1992 - 1993 Corvette: Service Bulletin: Cracks/Damage to Cowl Surface

Subject: CRACKS OR DAMAGE TO COWL SURFACE

Model and Year: 1992-93 CORVETTE WITH RPO LT1 ENGINES ONLY

Bulletin Number: 93-134-10

VIEW A

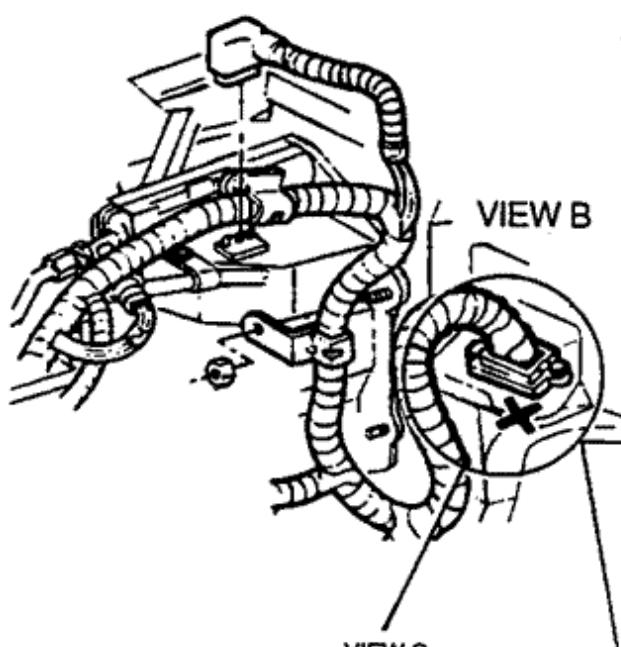
4. Remove right side A.I.R. pipe from engine (See View A);
 - a. Remove nut at exhaust manifold, use 22 mm "crow foot" wrench.
 - b. Loosen bolt on rear of head, using long 9/16" open end wrench.

- c. Remove bolts on rear of intake manifold, use 10 mm 1/4" drive socket and flex extension.
 - d. Remove hose and plastic clamp from check valve.
5. Clean damaged area (See View B) with a wax and grease remover and use V.O.C. approved materials where required.

VIEW C
(X SHOWS DAMAGE AREA)

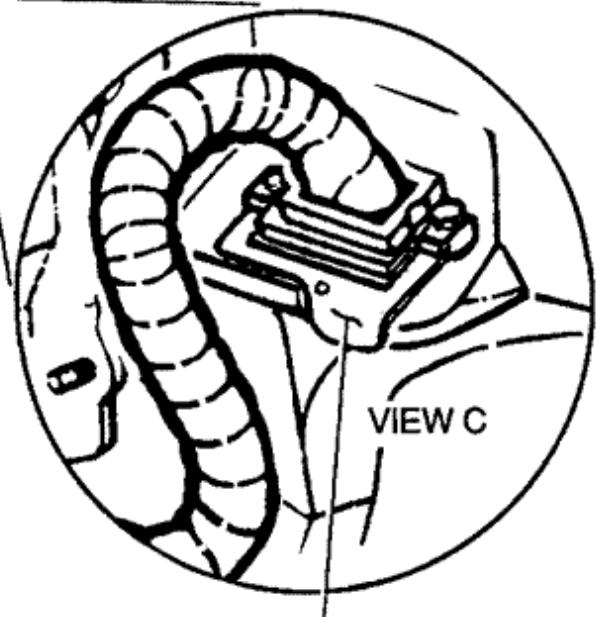
Some 1992-93 Y-cars with LT1 engines may have cracks or damage to the cowl surface:

- Behind the right cylinder head, - Below the wiring harness connector.

Rear of engine may contact the cowl surface when removing transmission or engine from vehicle.

6. Apply enough seam sealing material to fill or cover the damaged area. Paddle material into place, if required.
7. Loosen the harness connector attaching bolts, position GM P/N 10231336 - Spacer, over the damaged area and under the attaching bolt heads and tighten the attaching bolts. The spacer has slots to aid in installation (See View C).

NEW PART IN POSITION
OVER DAMAGED AREA
